NOTICE TO PROSPECTIVE BIDDERS
ADDENDUM NO. 1

PROJECT ID NO. SWQ0000003

LADERA PARK STORMWATER IMPROVEMENTS PROJECT

Pre-bid Questions and Answers

SITE DEMOLITION PLAN AND

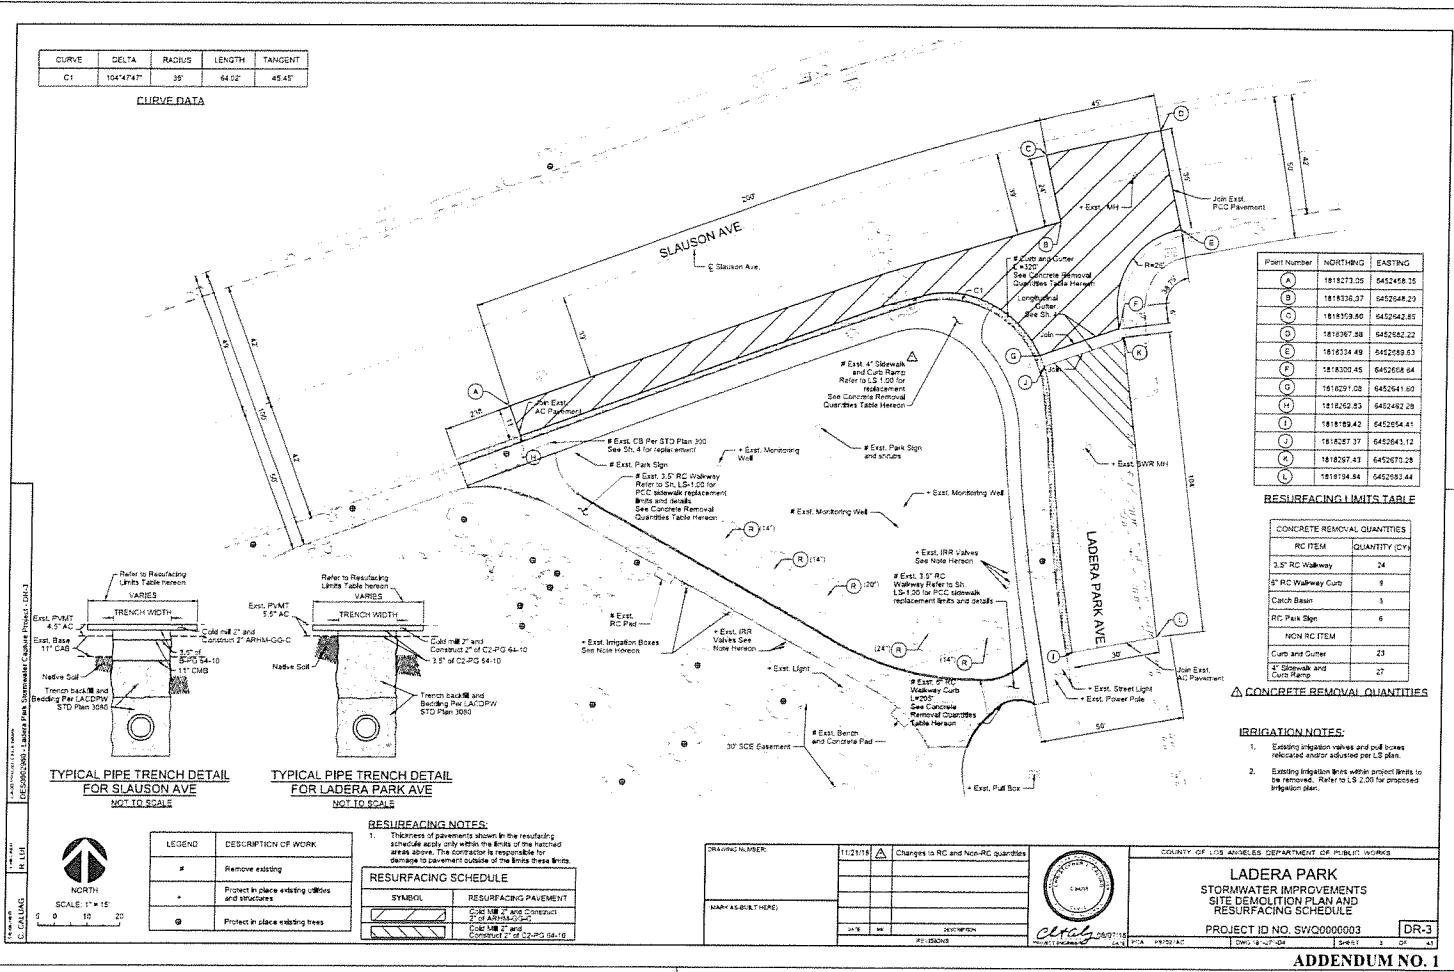
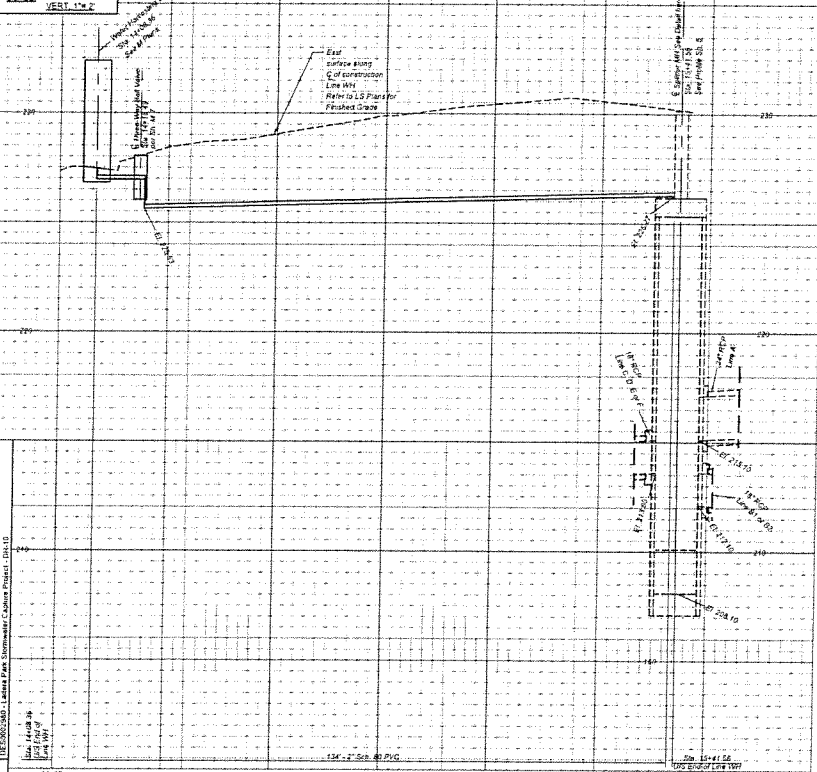
Q5. *The RC Item quantity (68 CY) shown in the Concrete Removal Quantities on Sheet 3 does not match Bid Item No. 12.4- Concrete Removal (Reinforced): 42 CY. Please clarify the discrepancy in the quantities.*

Q6. *The Non-RC Item quantity (21 CY) shown in the Concrete Removal Quantities on Sheet 3 does not match Bid Item No. 12.3- Concrete Removal (Non-Reinforced): 50 CY. Please clarify the discrepancy in the quantities.*

CHANGES TO RC AND NON-RC QUANTITIES

A5. Refer to the quantity tables on the revised Sheet 3 at the end of this Addendum 1.

A6. Refer to A5.

COUNTY OF LOS ANGELES DEPARTMENT OF PUBLIC WORKS
LADERA PARK
 STORMWATER IMPROVEMENTS
 PROFILE LINE WH & SPLITTER DETAILS
 PROJECT ID NO. SWQ0000003 DR-10
 SHEET NO. 15 OF 15

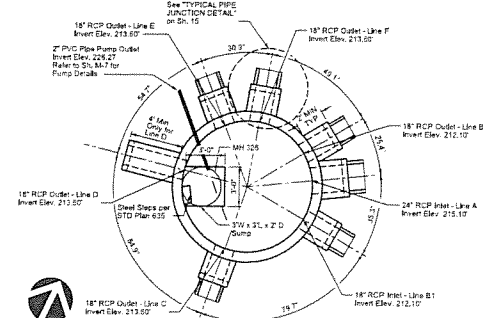
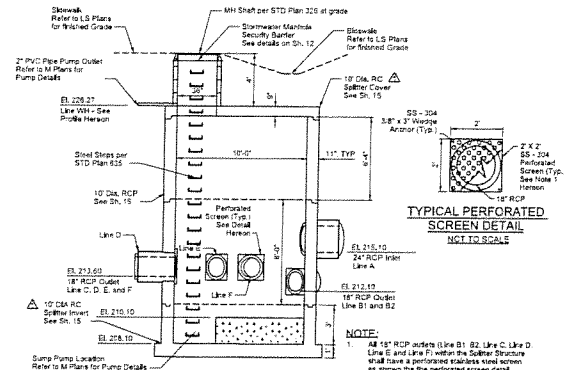
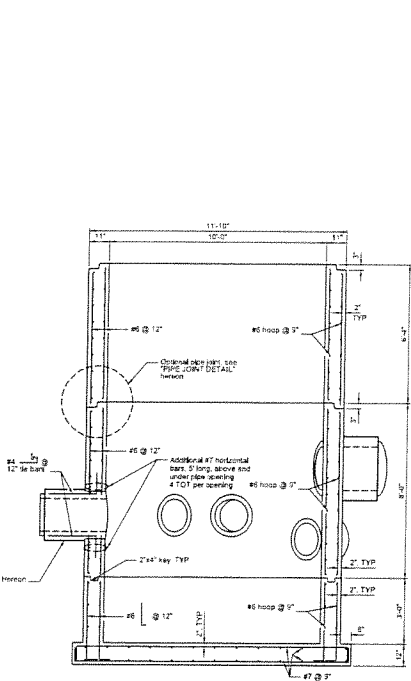
Q4. *Is the Splitter Structure shown on Sheet 15 a precast or a cast-in-place structure? Also, Is it paid under Bid Item No. 12.9- Structure Concrete (Diversion Structure, Splitter Structure & 72" MH Footings and Top Cover) and Bid Item No. 12.10- Bar Reinforcing Steel (Diversion Structure, Splitter Structure & 72" MH Footings and Top Cover)? If it is a precast structure, there should be a separate bid item for the Splitter Structure.*

DESCRIPTION	11/2/11/11	Change from precast to RC
MARK AS-BUILT HERE		
DATE		
BY		
REVISION

A4. The Splitter Structure may be pre-cast or cast-in-place. Refer to the revised Sheets 10 and 15 at the end of this Addendum No. 1. There is no separate pay item for the splitter structure, payment is included in the Lump Sum Item No. 12 in the Bid.

LADERA PARK
STORMWATER IMPROVEMENTS
SPLITTER STRUCTURE DETAILS

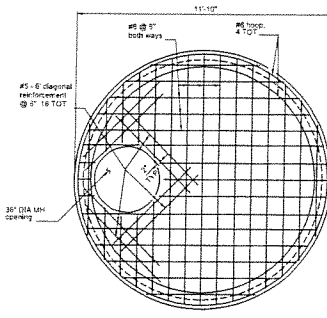
DATE	11/21/18	DESCRIPTION	Change from cast-in-place to RC
DESIGNED BY		CHECKED BY	
DRAWN BY		DATE
